Brightview Bethesda: Sketch Plan 320160010 and Preliminary Plan 120160010

Staff Report Date: 11/25/2015

- Two lots for an assisted living facility consisting of up to 120 dwelling units and 3,125 square feet nonresidential uses in an eight-story building and retention of an existing office building;
- Located in the northeast quadrant of the intersection of Rugby Avenue and Glenbrook Road in the Bethesda CBD;
- 1.39 gross acres zoned CR 3.0 C 1.0, R 2.75, H 90 T and CRN 0.5 C 0.5, R 0.25 H 35
- Woodmont Triangle Amendment to the Bethesda CBD Sector Plan* area;
- Application accepted July 23, 2015;
- Applicant: Shelter Development, LLC.
- Review Basis: Chapter 50 and Chapter 59

- Staff recommendation: Approval of the sketch plan and preliminary plan amendment.**
- The project is being developed with the use of FAR Averaging (density transfer) from two sending properties. The density transfer will send 19,000 square feet of residential floor area from the sending sites to the subject property.

② SUN STUDY - BRIGHTVIEW BETHESDA

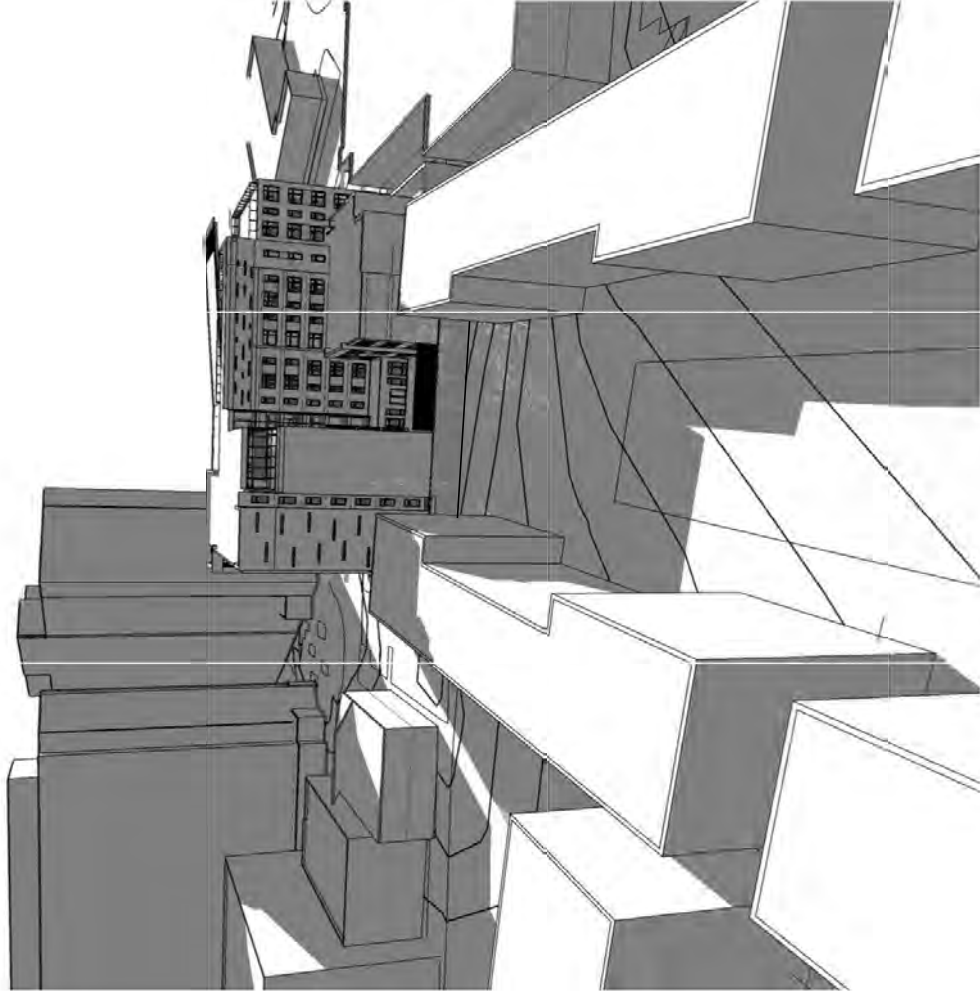
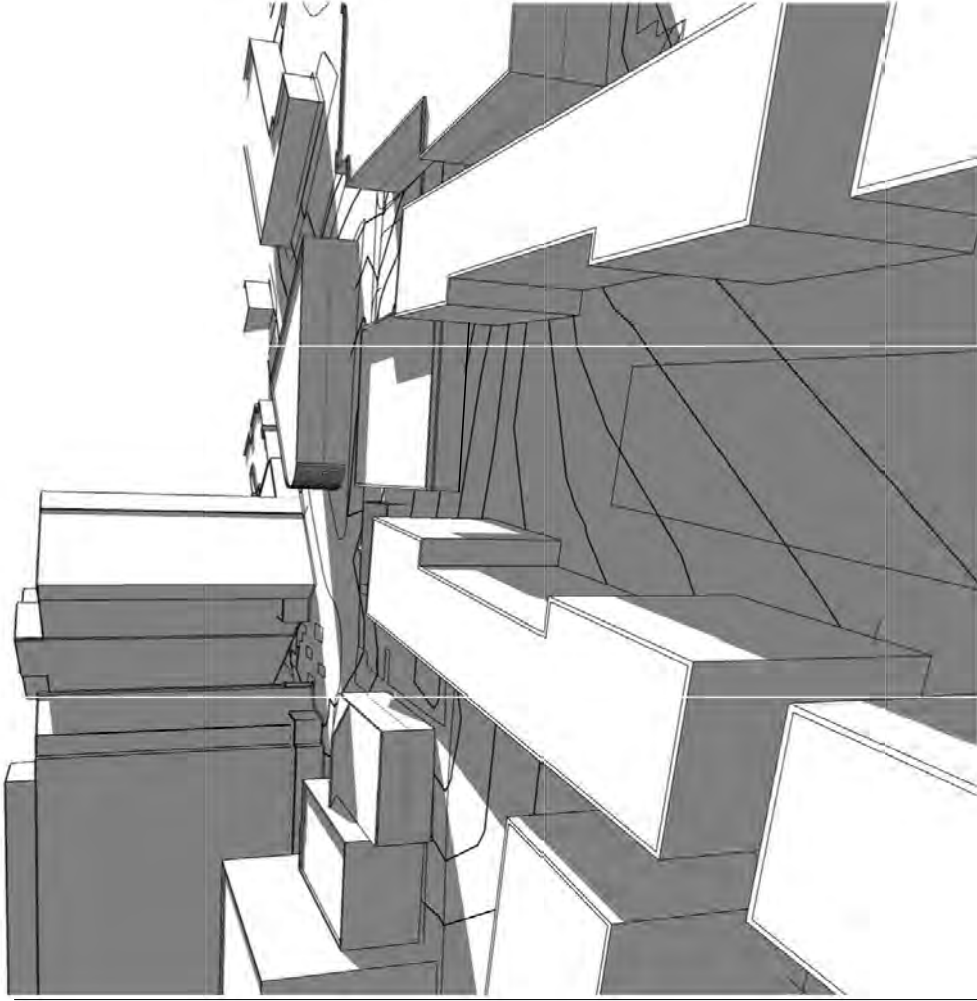
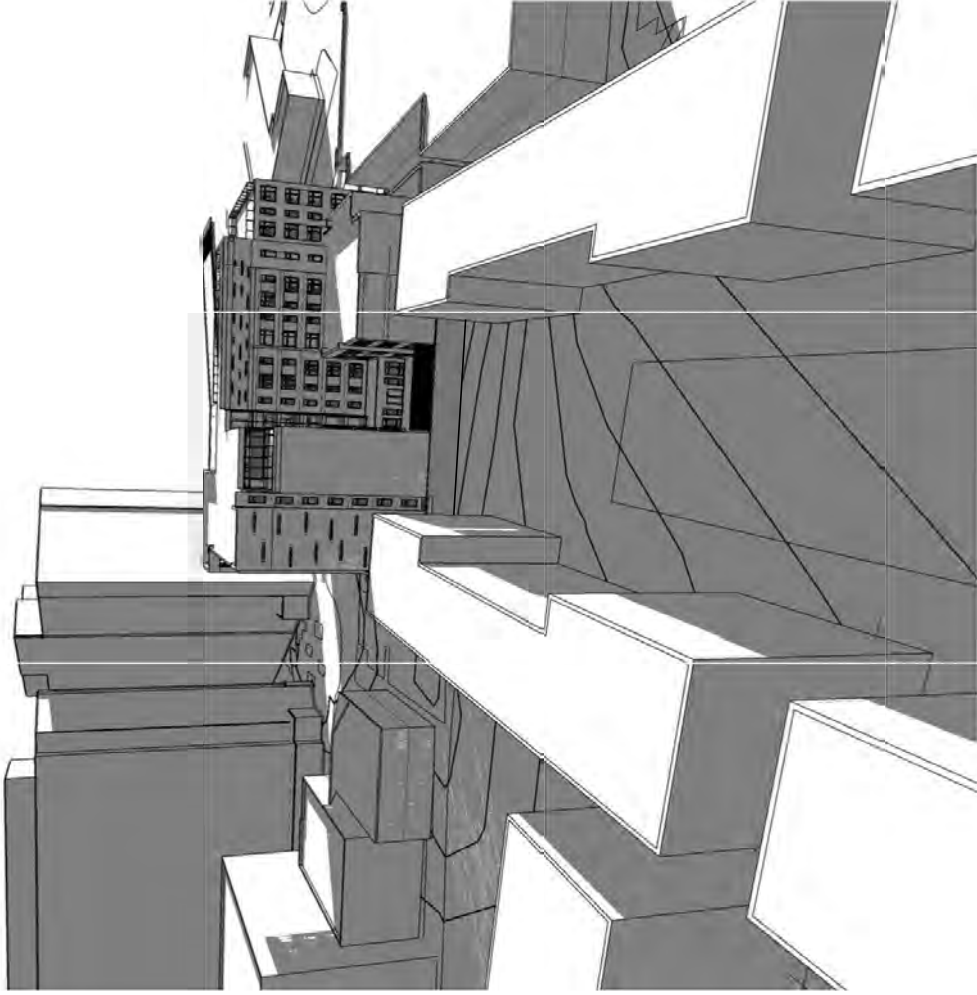
The applicant has complied with all submittal and noticing requirements. As of the date of this staff report, staff has received one letter on the application (Attachment D). The letter, from the managing member of the company that owns an adjacent garden apartment complex, raised concerns about the proposed building's potential to create excessive shadows on the garden apartment property. In response to the letter, staff requested that the applicant provide a shadow study for the project (Attachment E). As discussed below, the shadow study shows that construction of the proposed building will not substantially increase the amount of shadow that is cast onto the garden apartment property.

That would simply be unfair. The economic value of our property would be severely compromised – it is likely that we would be unable to rent at least half of our apartments for anything close to the already very low rents we are charging for them now. How many tenants do you think would want to rent an apartment at all that would be rendered into virtual darkness for so much of the day and so much of the year?

We have met with the architect of the project – a nice person who has tried to placate us by getting the developer to lower one side of the building by one floor. But that will not suffice – the building is too big as proposed. I am confident that one property owner is not permitted to drastically reduce the economic value of a neighboring property. So I ask that you deny this application as submitted – perhaps Brightview can develop a better plan that would not so drastically affect our property.
